CONSTRUCTION SUMMARY
EARLGLEN INVESTMENTS INC.

LOT NUMBER	PHASE	HOUSE TYPE	CLOSING DATE
110 BLOCK 017	1	THE ELIZABETH(CORNER)-ELEV A-3 BDRM-2 BATHS	08-Sep-26

Date Added: 02-Jul-25 Invoice Number: 8853

SECOND FLOOR PLAN, 'EL. A'
OPT. PRIMARY BEDROOM LAYOUT

Cable (x2)
Telephone (x2)
Conduit (x1)

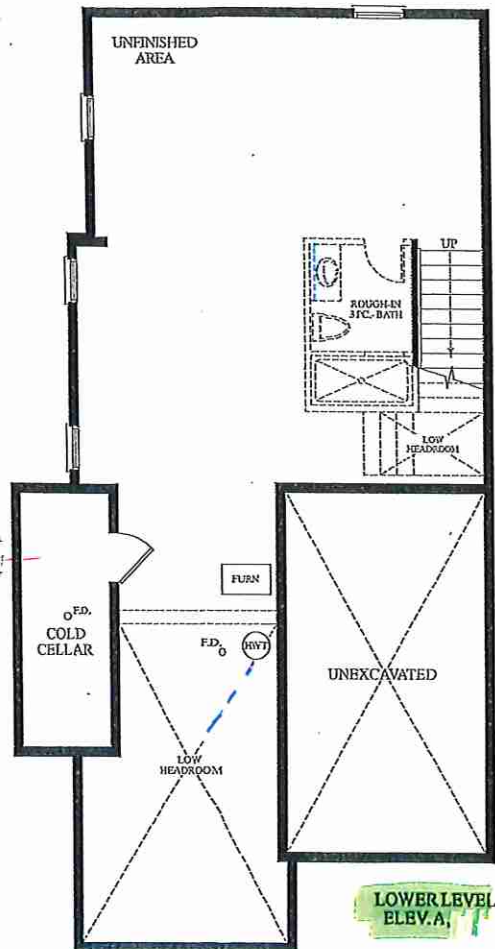
1 - Install Standard Cable Rough-Ins (x2) and Install Standard Telephone Rough-Ins (x2) (See Sketch) Note:
1 - MAIN FLOOR & UPPER HALL - FLOORING - Install UPGRADE Laminate Flooring - 7 1/2" TORLYS HIGHLAND ALDERSON OAK EEH-285 in lieu of standard Red Oak Natural Laminate. To be installed throughout main floor and upper hall, where applicable. Note: To Include; Den, Great Room, Upper Hall and Applicable Landings (See Sketch)
1 - STAIRCASE - Stain Oak Staircase from Main Floor to Second Floor, where applicable. To be Stained - Vintage Red Oak PEWTER - To Include: Treads, Risers, Handrail and Post, where applicable (See Sketch) Note:
1 - STAIRCASE VS FLOORING WOOD SPECIES DIFFERENCE: STAIRCASE - The purchaser was advised and therefore accepts and acknowledges that the wood species of the staircase and flooring chosen do not match. This difference may result in a stain colour variance. Note: The purchaser agrees that the vendor is to be exempt from any and all claims by the purchaser regarding this colour variance.

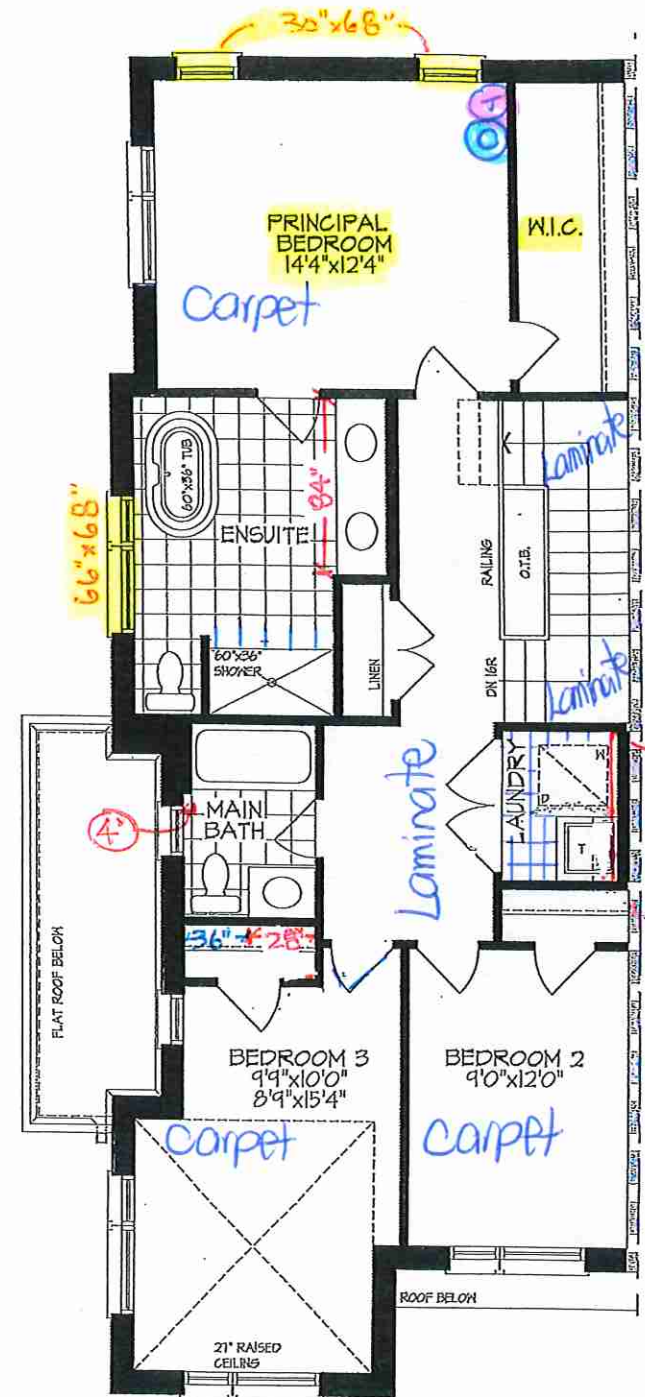
1 - PRIMARY BEDROOM - Delete standard closets at primary bedroom. Install Walk-In Closet at primary bedroom. Windows at back elevation to be reduced. Bedroom size to be reduced to accommodate walk-in closet (See Attached Revised Layout) Note: **No Charge As per Fonzie C.**
1 - PRIMARY ENSUITE - Install Standard Free Standing Tub STRAIGHT. Delete two standard windows at fron elevation. Install ONE (1) Window Centred at front elevation of primary ensuite (See Attached Revised Layout) Note: **No Charge As per Fonzie C.**

KITCHEN PLAN

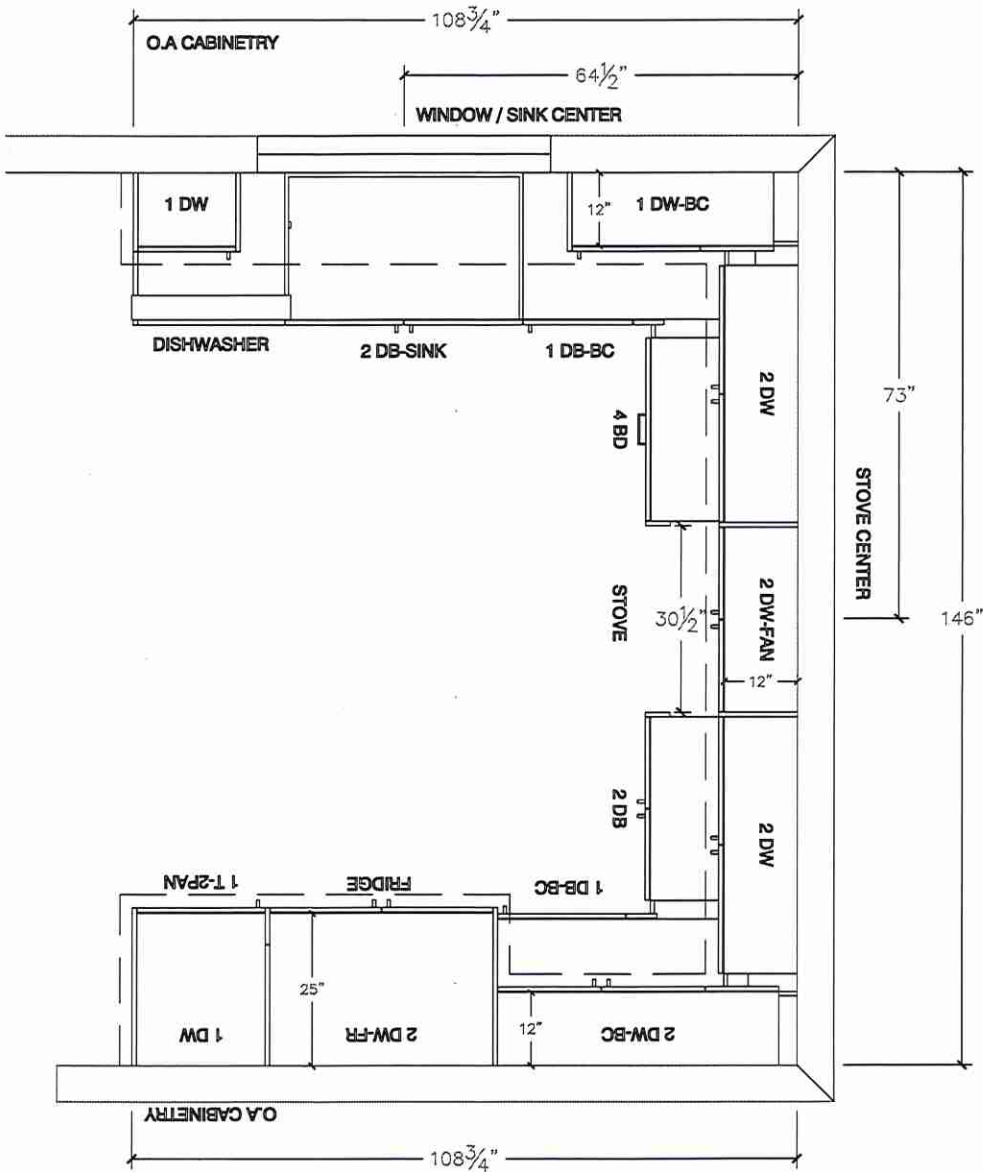
* WINDOW CENTER TO BE MOVED AT 64.5"
